INAC, Nunavut District

NWB1BQS9801

re: October 18, 2000 reply to Water Licence Inspection Report

figure 7. Unlined sump in periphery of the ore pad; 2000/08/02. (courtesy of DFO)

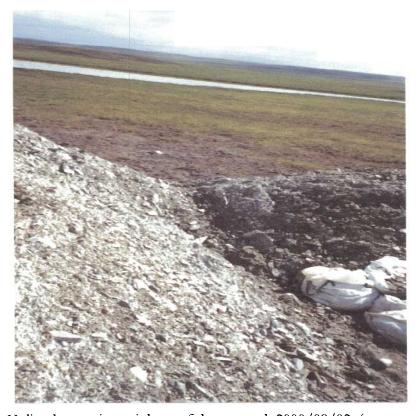
- Unlined sump in periphery of the ore storage pad: At the time of the inspection, the sump contained approximately a dozen tattered bags of drill cuttings (figure 6). However, subsequent observations reveal the disposal of solid waste at the site (figure 7). In this regards, the Inspector reminds the Licensee that part F of the Water licensee defines the need for prior notice relating to modifications of undertakings. Moreover, the notch in the berm (figure 8), as well as the base of the sump (figure 9), seem saturated. Further, what appears like a channel in the berm of the adjacent lined sump is noticeable (figure 7), while an uncharged line sits atop the sump's berm (figure 9), next to an area where pooled water can be observed (figure 10). In addition, signs of notable runoff are apparent downslope of the ore pad sumps (figures 11-12). Accordingly, the Inspector directs the Licensee to:

- halt all disposal of solid waste in the ore storage pad area before the planned modification is submitted to, and duly approved by, the NWB.
 - confirm that at no time this summer was the sump included in the path of a discharge.
 indicate, in the contrary, the nature of the discharged substance(s).
